Amersham
QSA

13 May 1995

Attachment 1

Our review of the NRC Special Inspection report reveals the following inaccuracies. These inaccuracies were discussed by phone with Dr. Shanbaky and Ms. Lanzisera on 24 April 1995.

Radioisotope Laboratory Layout

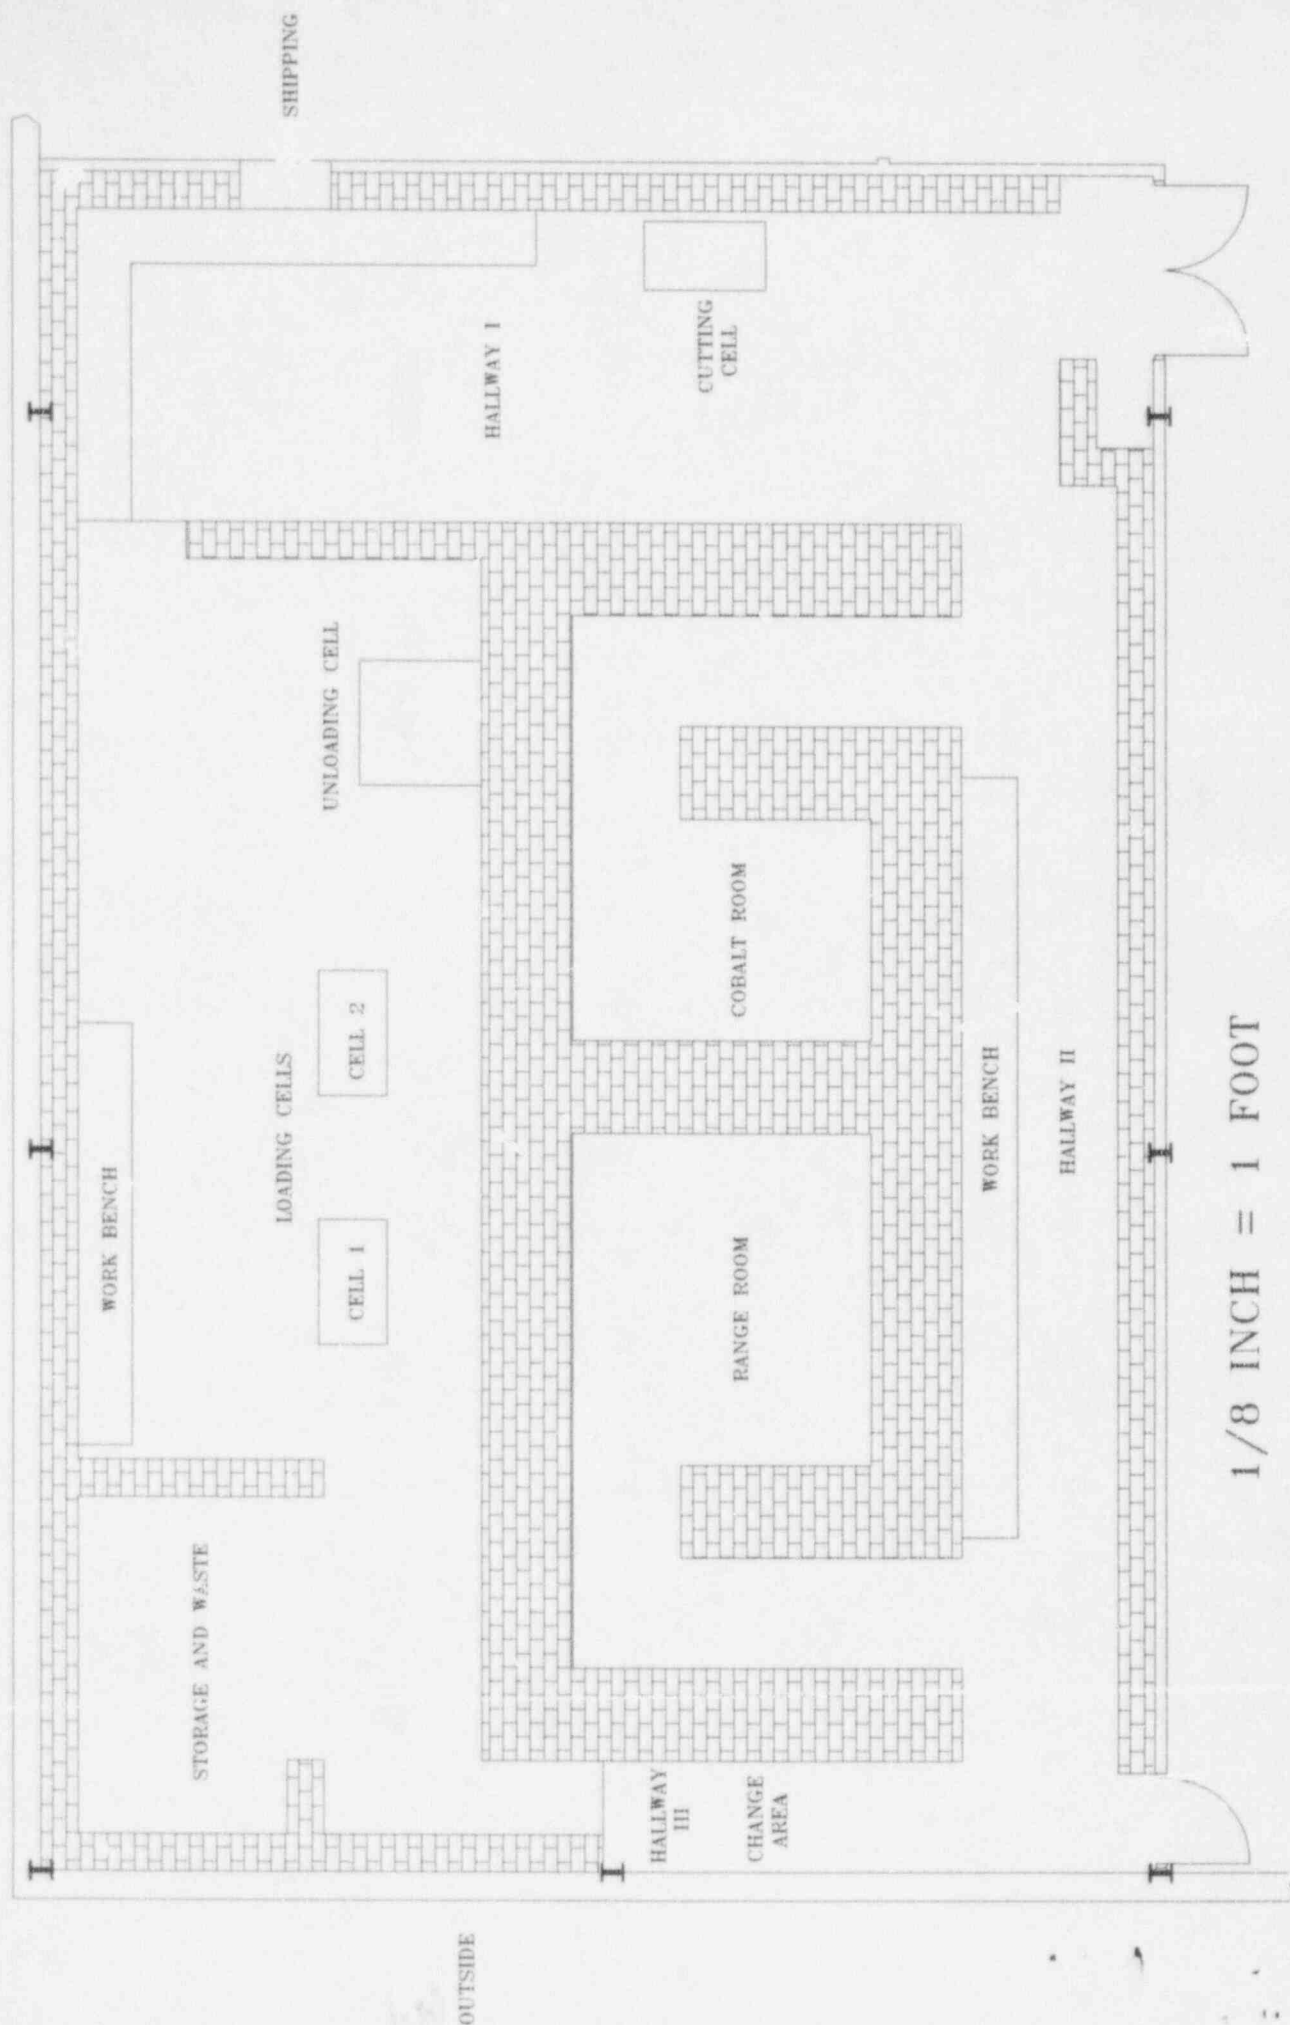
"There have been many cases, including the present one, in which workers were contaminated though they had not engaged in any work that involved handling contaminated items or working close to an ongoing operation that involved such items."

The statement in the inspection report seems to imply that there

should be clean areas within the contamination control zone. The contamination control zone is the entire back area of the Radioisotope laboratory as indicated in the attached layout (Appendix 3). Although steps are taken to minimize and control contamination in this area, all activities performed within this area are assumed to involve handling of potentially contaminated items and surfaces, and the appropriate precautions are taken.
